# UNITED STATES PATENT AND TRADEMARK OFFICE

APPLICATION NO.	FILING DATE	FIRST NAMED INVENTOR	ATTORNEY DOCKET NO.	CONFIRMATION NO.
10/786,294	02/26/2004	William F. Geraghty	21377	3434

<b>Office Action Summary</b>	Application No. 10/786,294	Applicant(s) GERAGHTY, WILLIAM F.	
	Examiner Árpád Fábíán Kovács	Art Unit 3671

## **DETAILED ACTION**

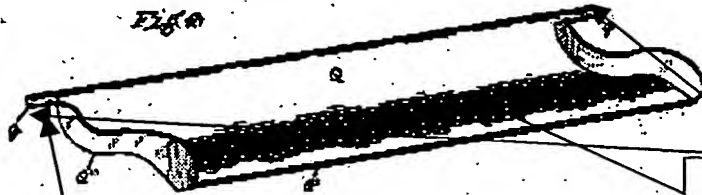
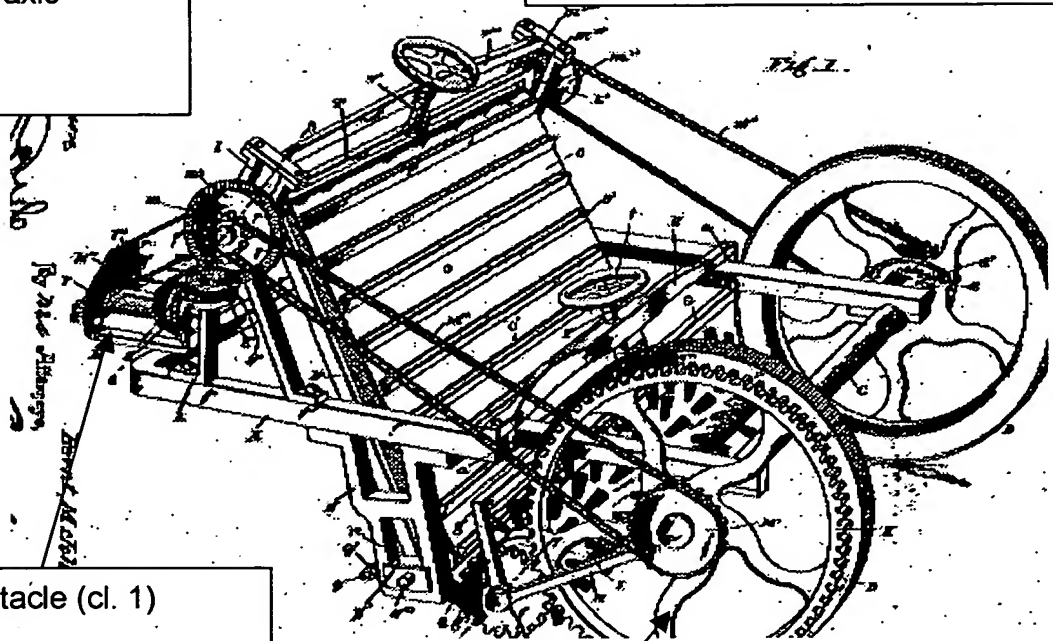
3. Claims 1-7, 20-31 are rejected under 35 U.S.C. 102(b) as being anticipated by Johnson (501515).

Johnson discloses:

Pivot axis

Transverse, curved, pair of radial arm sections, skid surface & ground engageable end, counterweight end (cl. 1-4, 6, 20-27, 29-30)

Receptacle (cl. 1)

Set of wheels (cl. 28)
